**Proposal for a Corrigendum to ECE/TRANS/WP.29/2007/2**  
(Draft Revision 6 of Regulation No. 13)

Note: During its sixtieth session, GRRF adopted a number of amendments to Regulation No. 13 (see report ECE/TRANS/WP.29/GRRF/60, paras. 4, 6, 8, 11, 12 and 16) and requested the secretariat to submit them to WP.29 and AC.1 for consideration at their March 2007 sessions. For that purpose, the secretariat prepared a consolidated document (ECE/TRANS/WP.29/2007/2) of Regulation No. 13 intended to be published, after its adoption by WP.29 and AC.1, as a new Revision 6 of the Regulation. Following the publication of ECE/TRANS/WP.29/2007/2 on 19 December 2006, the secretariat received a number of corrections as reproduced below. The intention of the secretariat is to prepare, after confirmation by GRRF, an official Corrigendum 1 to ECE/TRANS/WP.29/2007/2, for consideration at the March 2007 sessions of WP.29 and AC.1.

DIAGRAM 1

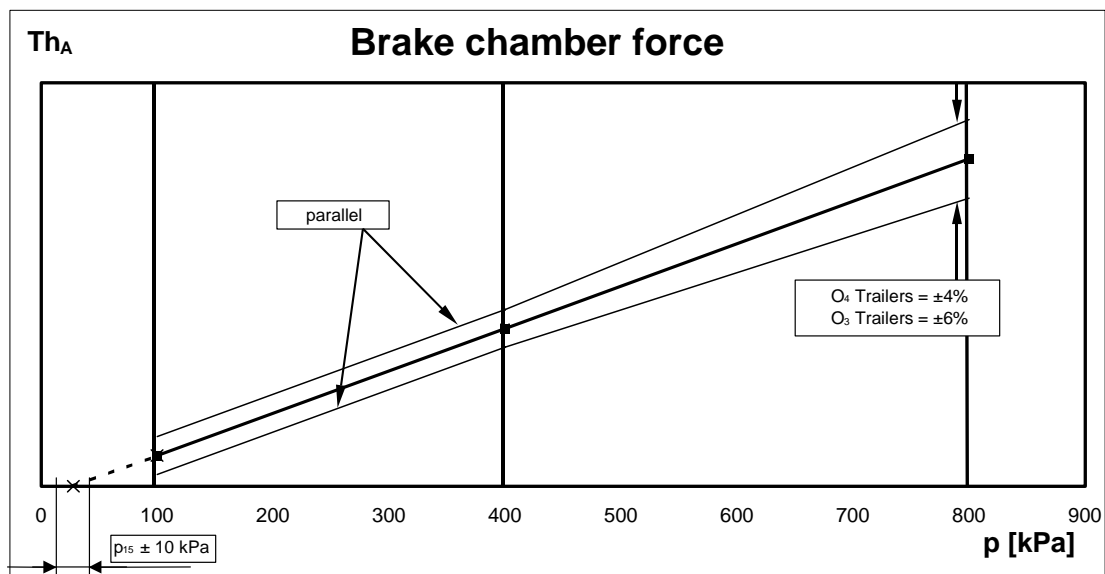
Page 216, Annex 19, diagram 1, replace the existing figure by the following one:

DIAGRAM 2

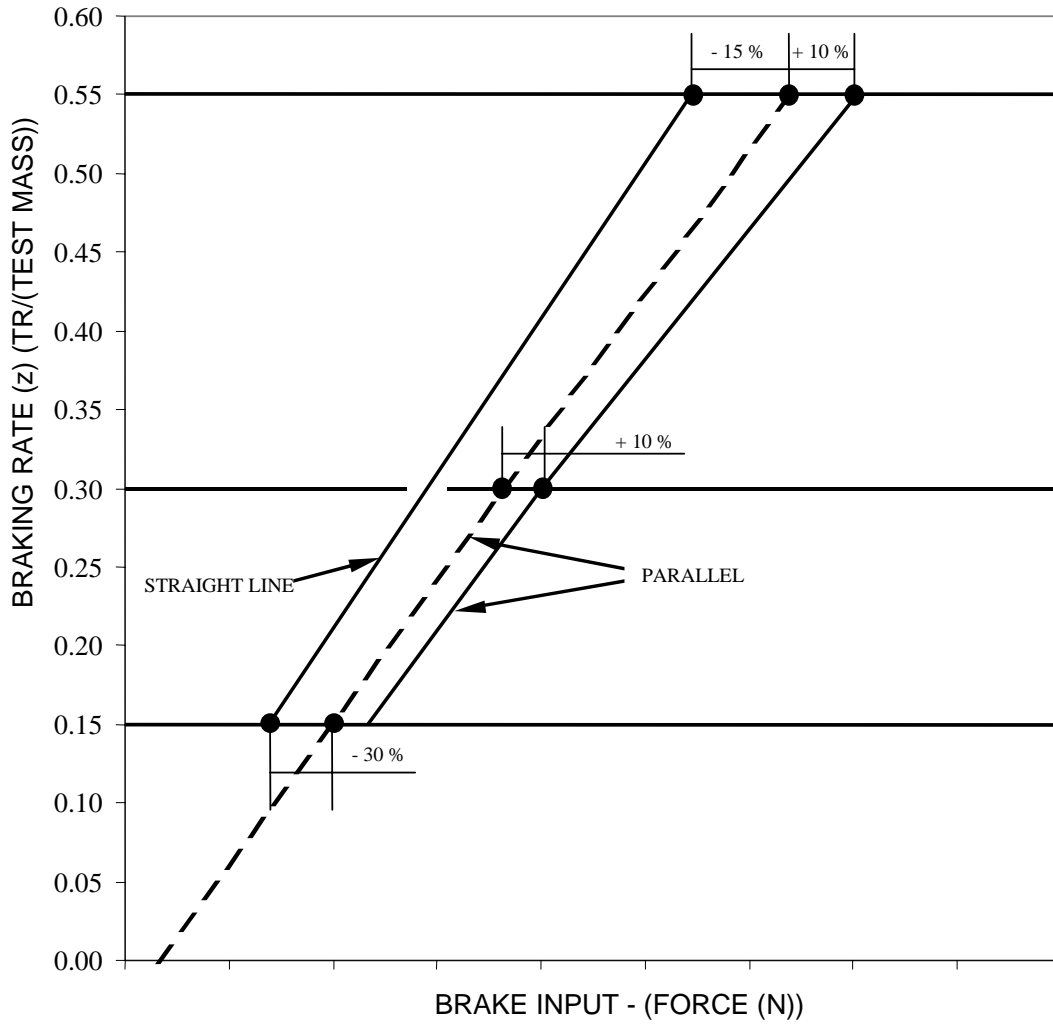
Page 230, Annex 19, diagram 2, replace the existing figure by the following one:
